SAFETY EVALUATION
PILGRIM NUCLEAR POWER STATION

Initiator	Dept.	Division	Document No.	Calc. No.	System Name
P.D. Harizi P.J. Doody	NESG	Mech. Eng. S&SA	PDC 83-62	M-662	Drywell

Description of Proposed change, test, or experiment: Replace all piping thermal insulation in the drywell with Owens-Corning NUKON fiberglass blanket insulation.

This Safety Evaluation supersedes SE No. 1638, Rev. 1 dated 8-6-84.

Figure 14.5-9. Total NPSH Available Rated Flow

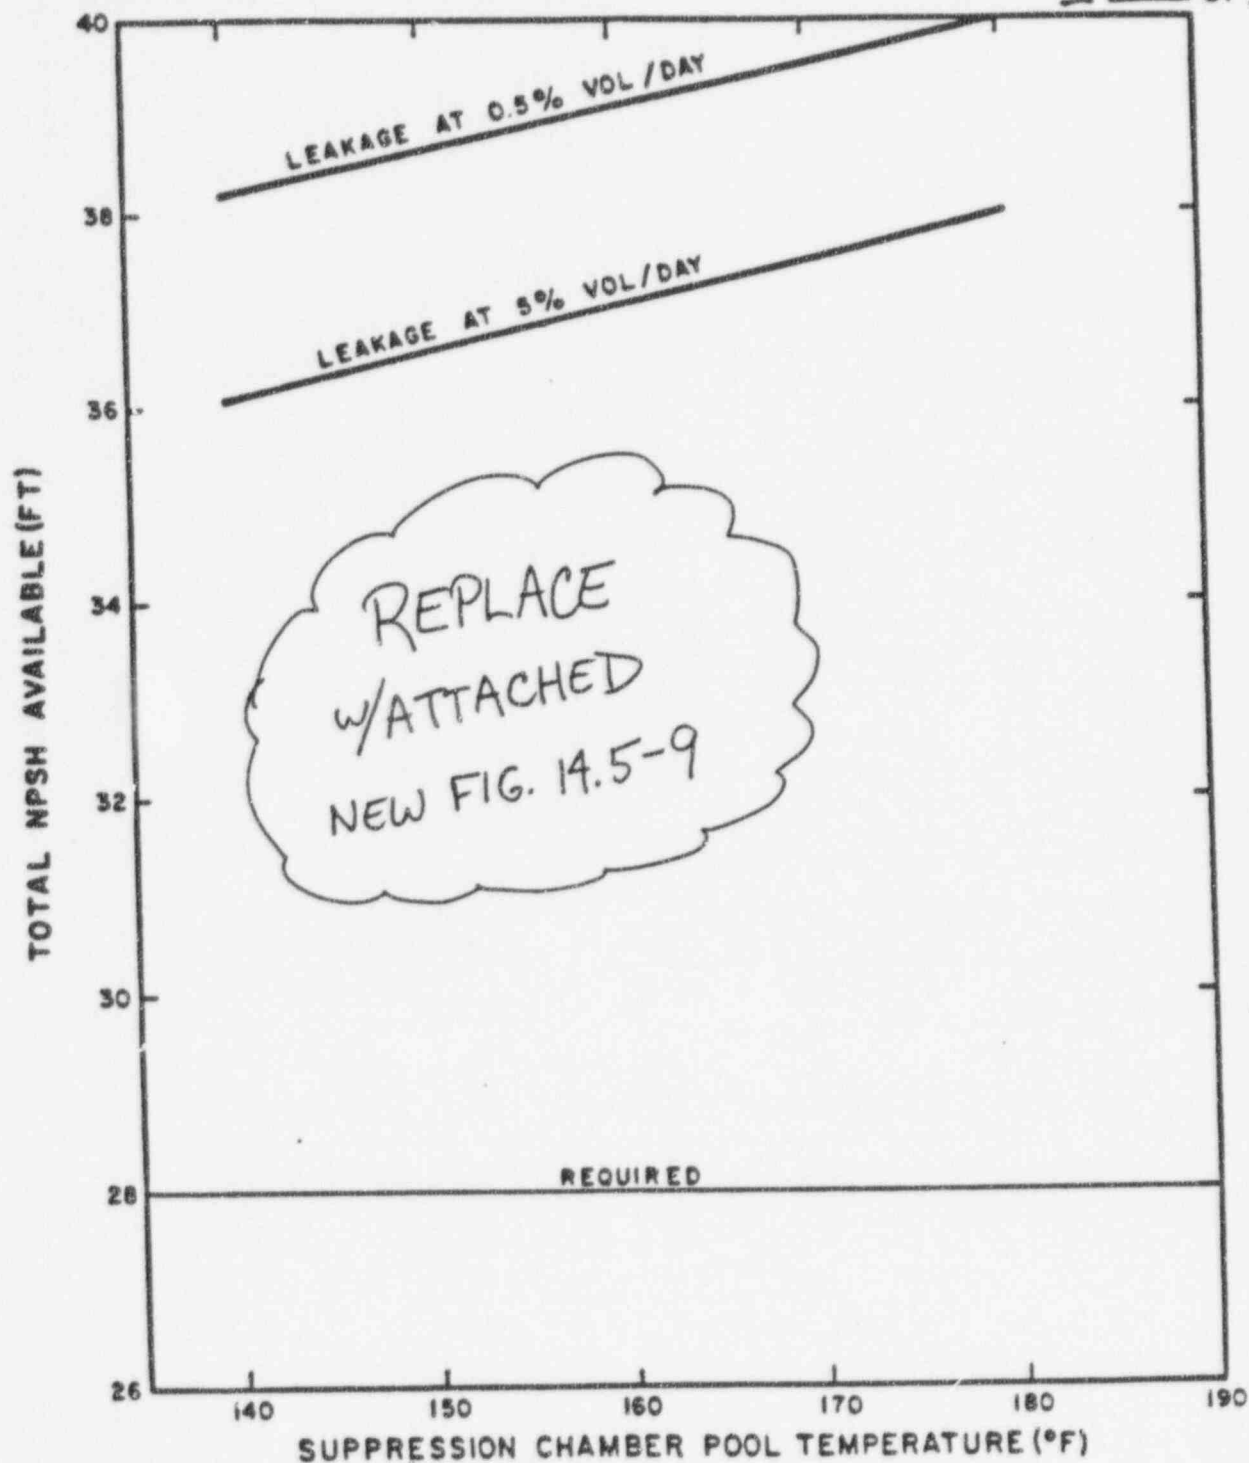
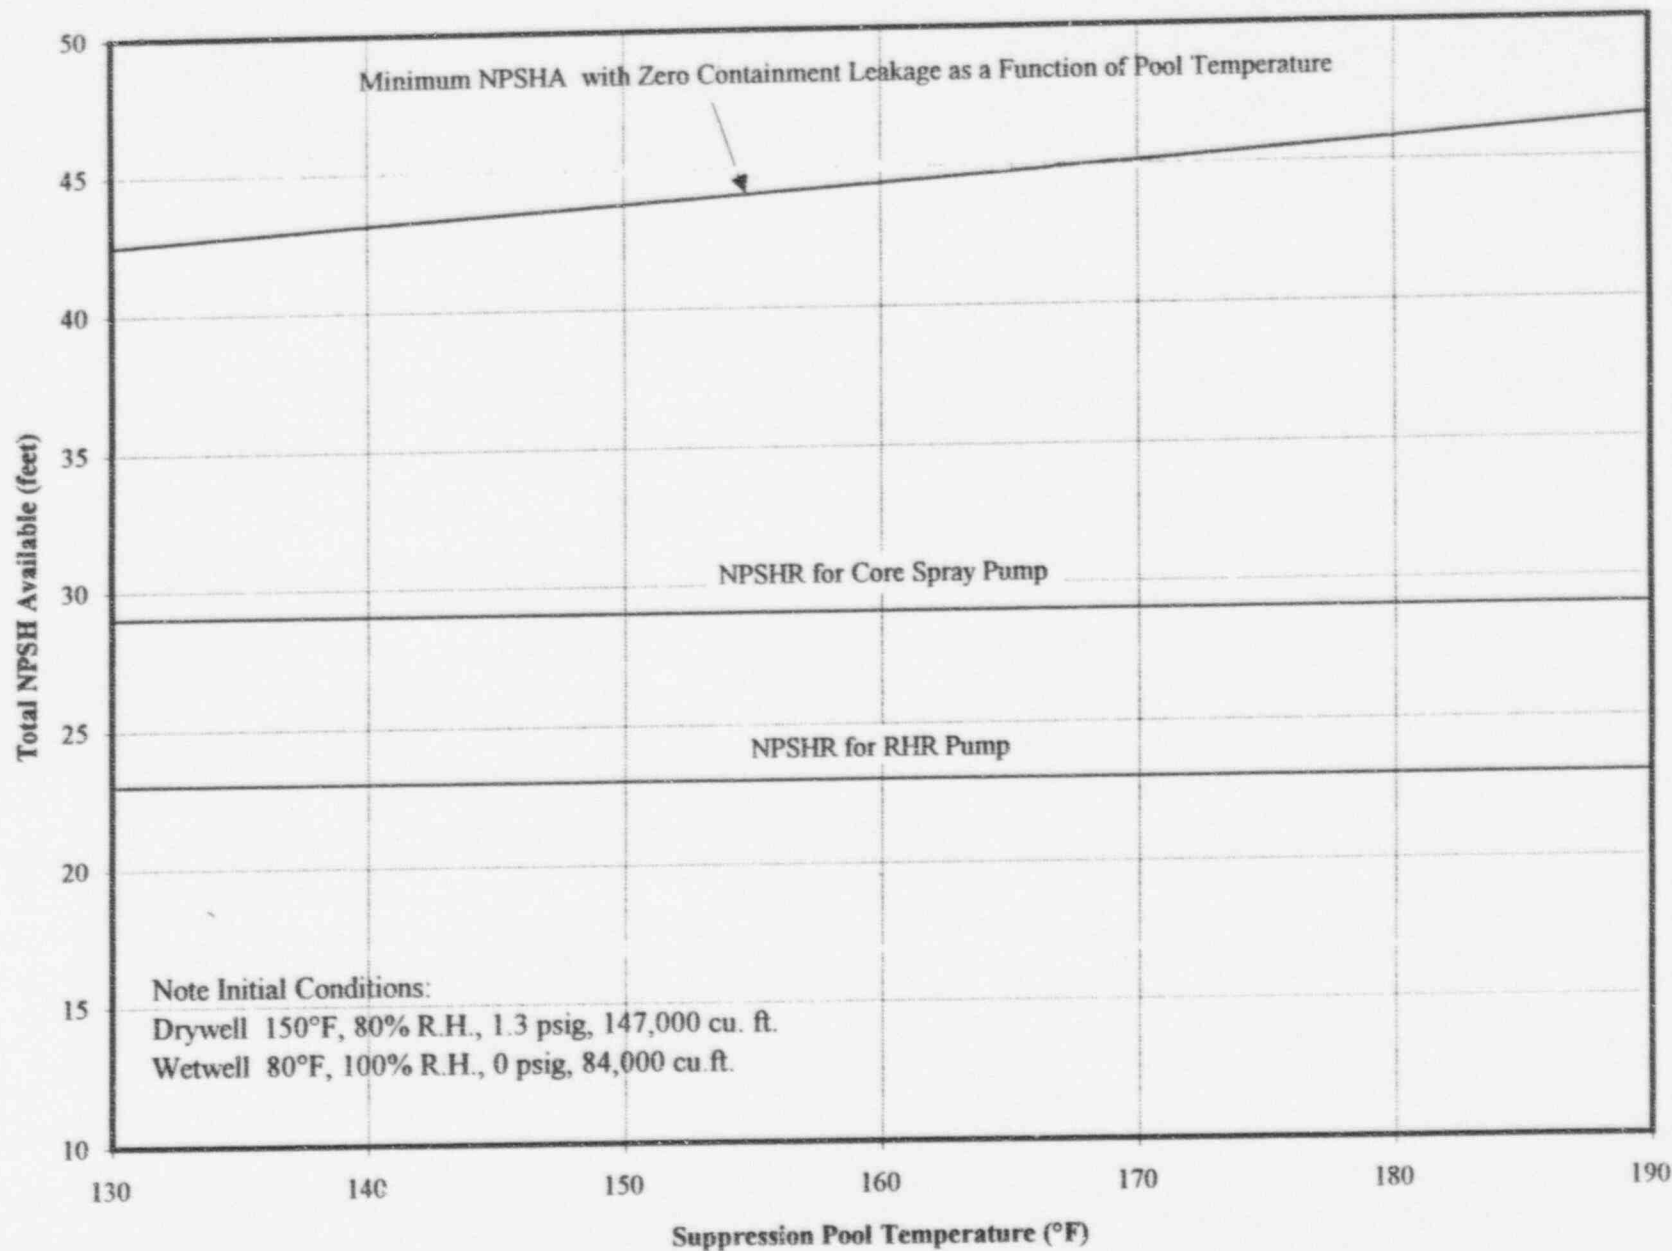
<u>Affected FSAR Section</u>	Preliminary revision to the affected FSAR Section is shown on:
<u>Section 4.8.5.1 (revise)</u>	Attachment 2
<u>Section 6.4.3 (revise)</u>	Attachment 2
<u>Section 14.5.3.1.3 (revise)</u>	Attachment 2
<u>Figure 14.5-9 (replace figure)</u>	Attachment 3
<u>Figure 14.5-10 (replace figure)</u>	Attachment 3
<u>Figure 14.5-13 (replace figure)</u>	Attachment 3

Included with this Safety Evaluation is a revision to the FSAR to replace Figures 14.5-9, 10, and 13 with updated figures generated from Calculation M-662 [Ref. 9]. The new figures are based on updated values for pump NPSHR, suction line loss, containment initial conditions, and the application of leakage calculated as a function of pressure rather than a flat mass reduction taken at initial conditions. The new figures also show that containment pressure does not continue to decrease below atmospheric pressure since this is not possible but was depicted as such on the original FSAR figures. In addition, the design value for containment leakage is now included as 1% per day at a reference pressure of 45 psig to be consistent with Tech Spec 4.7.A.2, and at 5% per day as before.

Figure 14.5-9 Total NPSH Available at Maximum Required Flow

Figure 14.5-10. NPSH Availability for RHR and Core Spray System

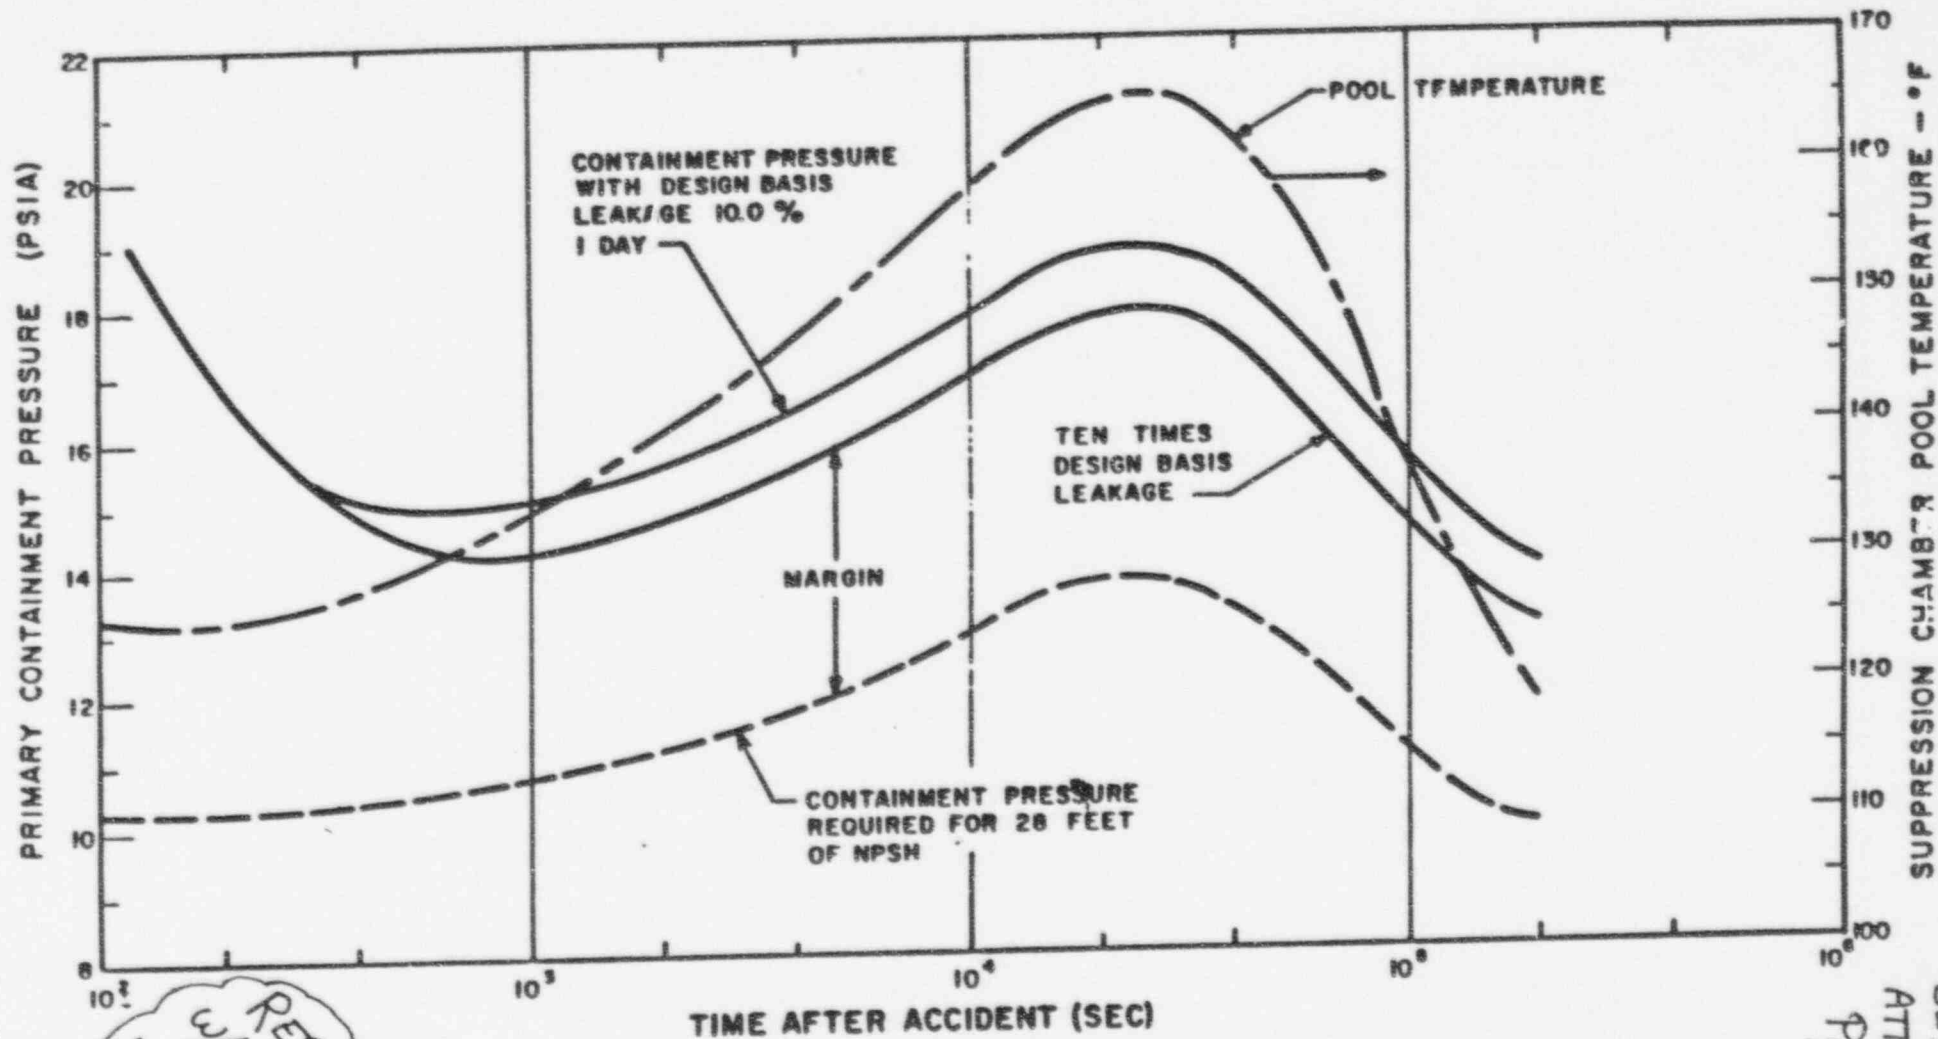
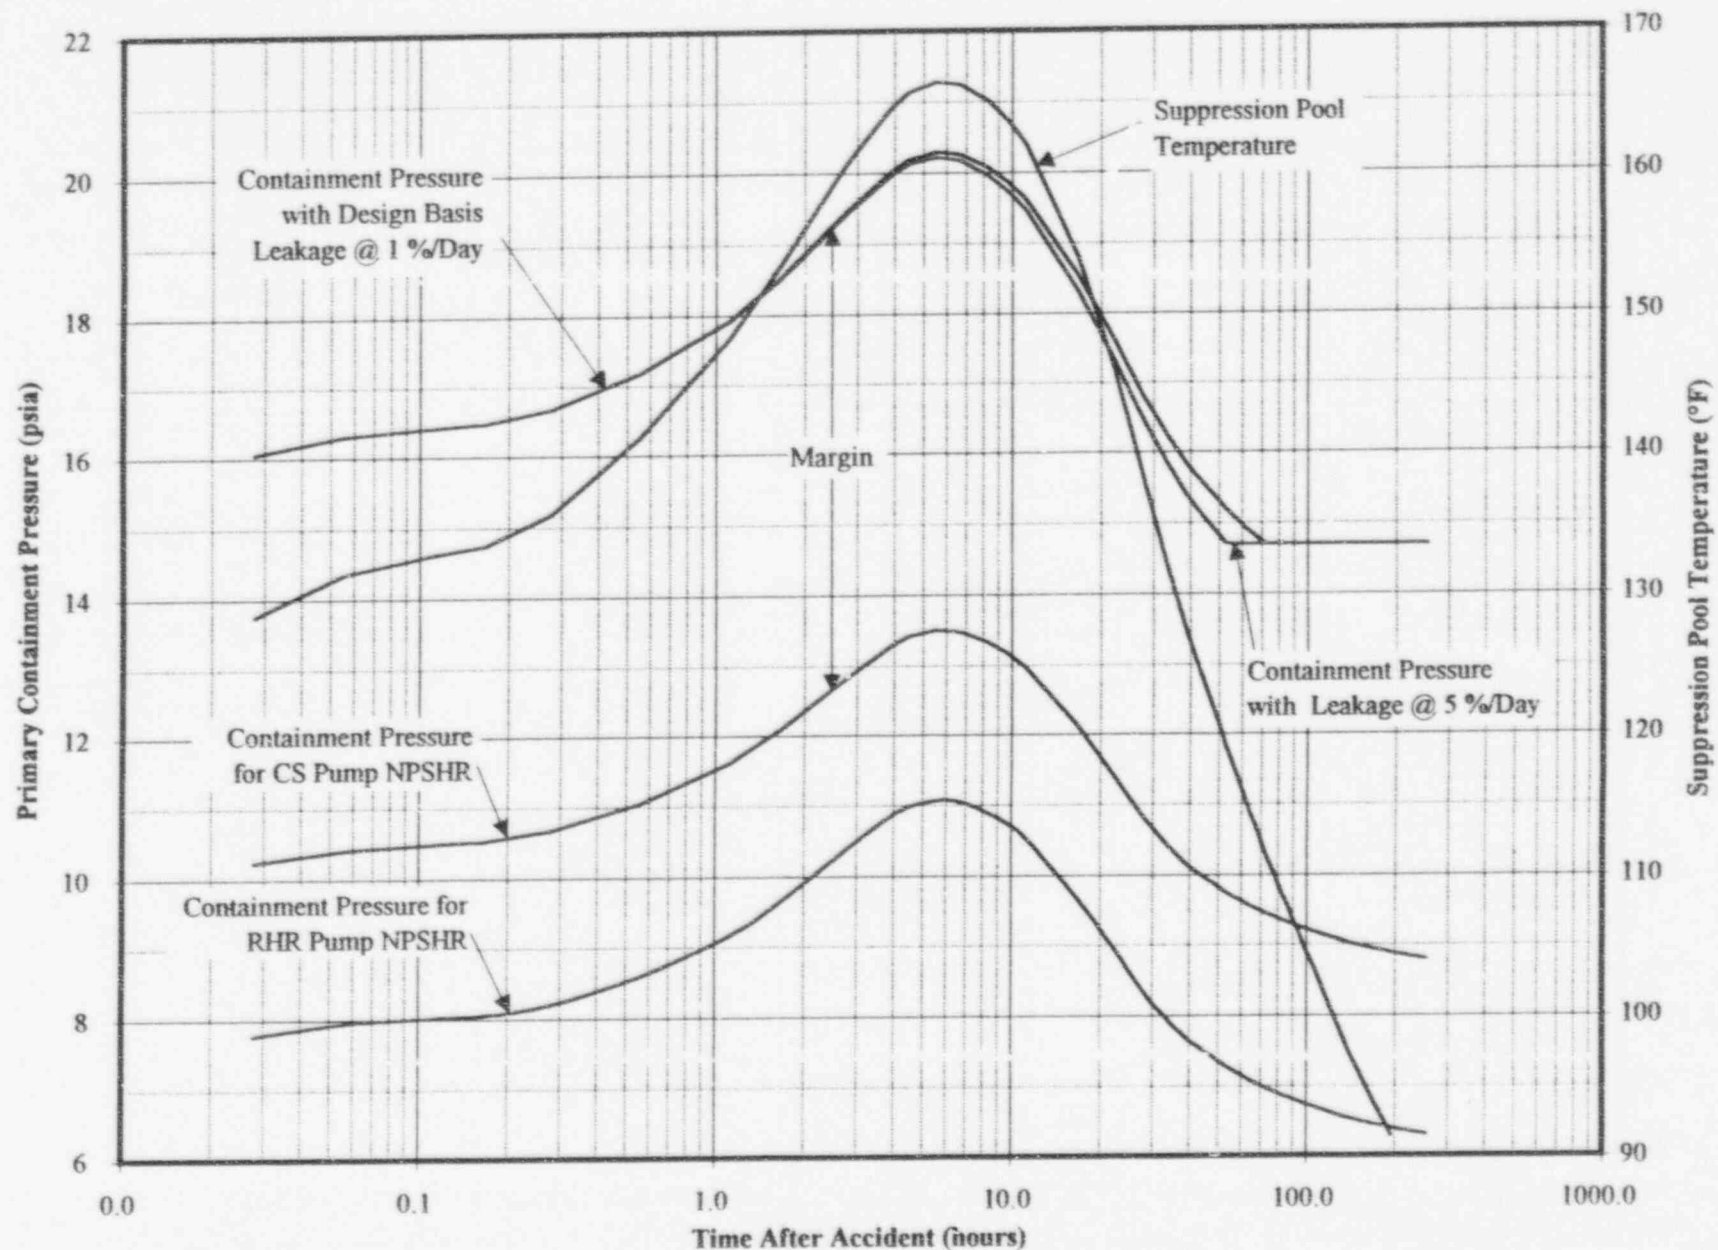
REPLACE
w/ATTACHED
NEW FIG. 14.5-10

Figure 14.5-10 NPSH Availability for RHR and Core Spray Pumps After a DBA-LOCA
